VIRGINIA ELECTRIC AND POWER COMPANY  
RICHMOND, VIRGINIA 23261

Serial No. 92-566A  
NL&P/EJW  
Docket No. 50-338  
License No. NPF-4

**VIRGINIA ELECTRIC AND POWER COMPANY**  
**NORTH ANNA POWER STATION UNIT 1**  
**SUPPLEMENT TO ASME SECTION XI RELIEF REQUEST**

Relief Request For Engineered Mechanical  
Clamp on Main Steam Line Drain Piping  
Supplemental Information

3"-SHPD-5-601-Q3  
NDER-92-382  
WO# 150738

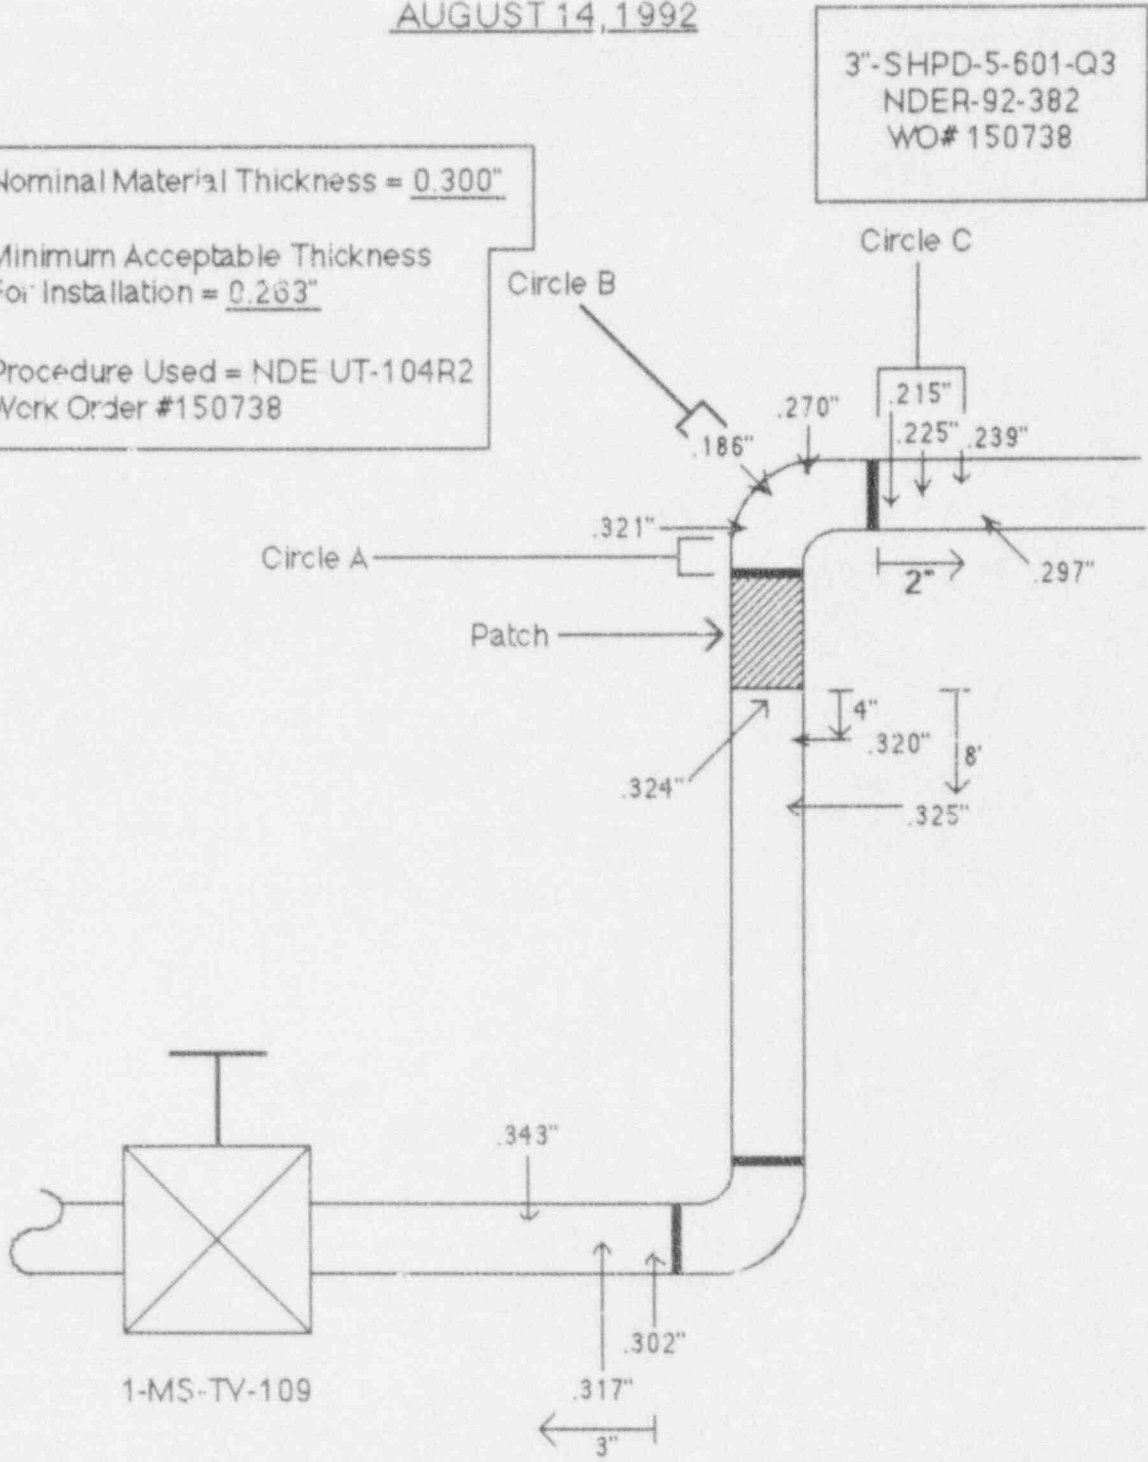
**4. Provide the results of any NDE performed to date.**

Nondestructive examinations performed on the affected section of line 3"-SHPD-5-601-Q3 consisted of initial ultrasonic examinations of several areas both upstream and downstream of the pinhole leak (primarily centered around the elbows immediately upstream of 1-MS-TV-109) and ultrasonic examinations of three circular cross-sections of the affected pipe. The results of these examinations are provided in Attachment 1 to this document.

Nominal Material Thickness = 0.300"  
Minimum Acceptable Thickness  
For Installation = 0.263"  
Procedure Used = NDE UT-104R2  
Work Order #150738

**NOTE:** Detailed readings were taken for the 'Circle' areas and are identified on Page 2 of 2.
